DEVELOPMENT REVIEW BOARD REPORT

ITEM NO. 3

28-DR-2000#3
Portales Residential

Request approval for modification to elevations, landscape and site plans along the east side of the project site only.

Proposed (SITE PLAN)
First Floor Plan

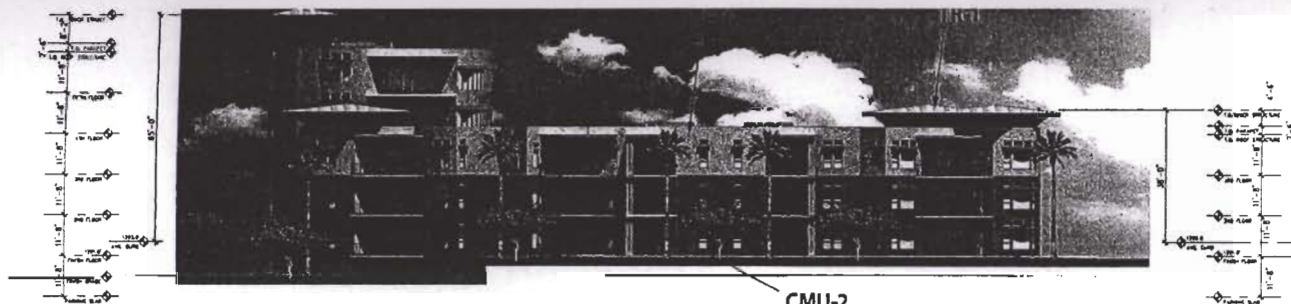
The site plan labeled “Proposed First Floor Plan” by DFD CornoyerHedrick with a staff date of February 28, 2005 shows the approved building footprint in a hatch pattern and the proposed building footprint in a solid line over the hatch pattern. The elevation plans by DFD CornoyerHedrick with a staff date of February 28, 2005 show the east, north, and south proposed elevations in color and the previously approved elevation plans in black and white.

The porte cochere is not apparent on the site plan, and seems inconsequential on the elevation plans. A more elegant and refined area with less emphasis on the vehicular experience and a greater emphasis on the pedestrian elements could be considered for this area. Refinements could include shortening the drop off loop, adding detail to the pavement treatments, providing landscaping, benches, tables, and activity features more common for pedestrian usage.

- c. The location and configuration of all site improvements shall be constructed to be consistent with the following:
 - (2) The site plan (labeled "Proposed First Floor Plan") submitted by DFD CornoyerHedrick dated 2/28/2005 by City staff.

East Elevation

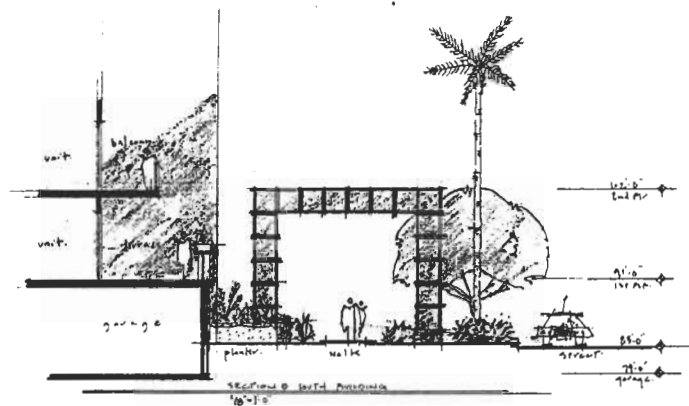
A second change affecting the massing and elevations is the elimination of the arcade element that has been replaced with 4 pedestrian pergolas and an entry porte cochere. The arcade of the original proposal provided a vertical transition, stepping the mass of the building to the ground. The result of this change is a building and ground plane relationship that is more dramatic and abrupt. The additional driveways for the drop off and parking access result in a loss of ground plane and building connections in some areas.

- a. Architectural elements, including dimensions and form shall be constructed to be consistent with the building elevations submitted by DFD CornoyerHedrick dated 2/28/2005 by City staff except as follows:

Conceptual
Landscape Plan
Date: February 24, 2005

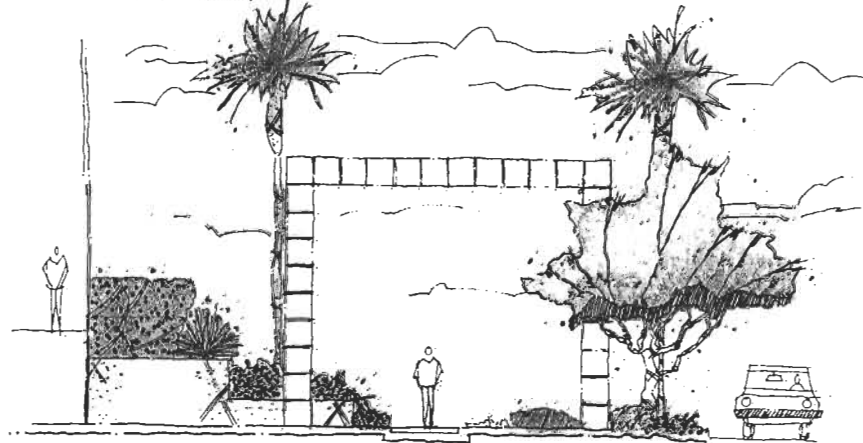
Conclusion. The overall impact of the elevation changes is not significant. The materials, colors, heights, and step backs are consistent with the original approvals. The overall changes to the landscape and pedestrian design is less desirable but does carry forward the landscape theme.

- (3) The amended development standards as approved in 76-ZN-1985 #3.
 - d. On-site landscaping, including quantity, size, and location of materials shall be installed to be consistent with the conceptual landscape plan approved in 28-SD-2000#2 except that the landscape plan design shall conform to the revised east portion of the site as shown on the site plan submitted by DFD CornoyerHedrick dated 2/28/2005 by City staff.
